**PLANNING UNIT REPORT**  
**DEPARTMENT OF PLANNING AND DEVELOPMENT**  
**January 9, 2006**

**RE: I.D. # 02454: Zoning Map Amendment I.D. 3157, rezoning 2313-2525 E. Washington Avenue & 2306-2422 Winnebago Street, 2317-2415 Winnebago Street and 11 S. Fifth Street from C2 (General Commercial District) and M1 (Limited Manufacturing District) to PUD-GDP**

Atch. Portion of Exhibit page 10 "Street Layout Plan" [10/26/2005]

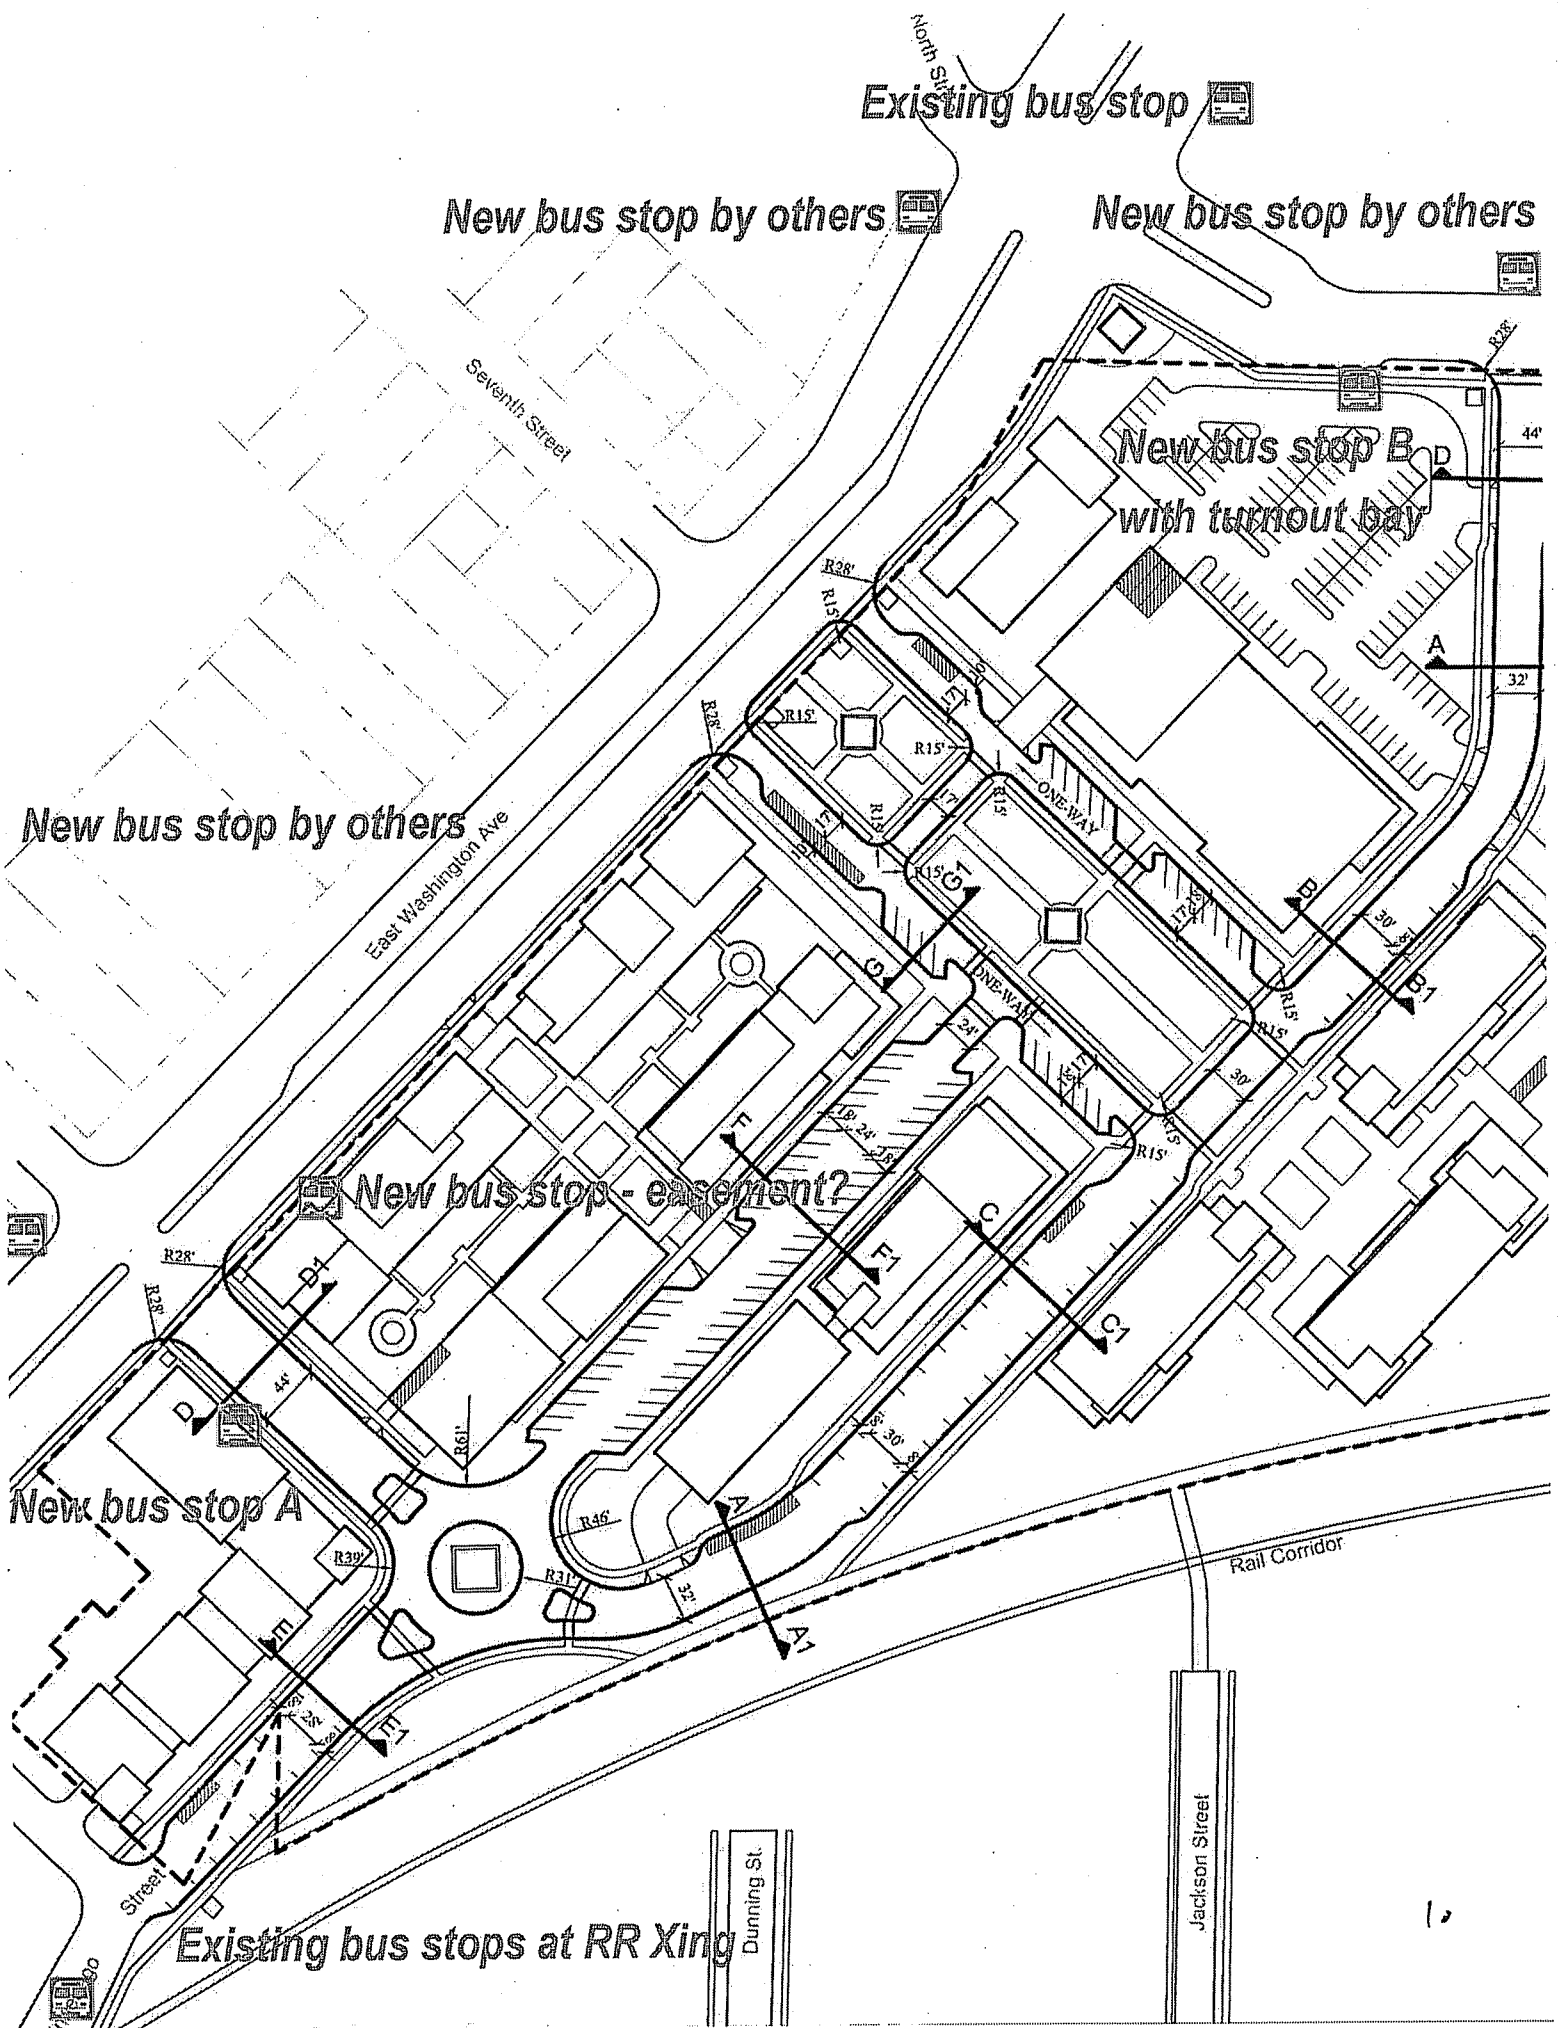
3. The applicant shall install and maintain a concrete passenger boarding pad on the south side of Milwaukee Street, at the east end of the bus turnout bay shown on the site plan. The concrete pad shall occupy the full distance of the terrace, measure a minimum of 6 feet in width parallel to the street, and lie flush between the sidewalk and the top of curb.
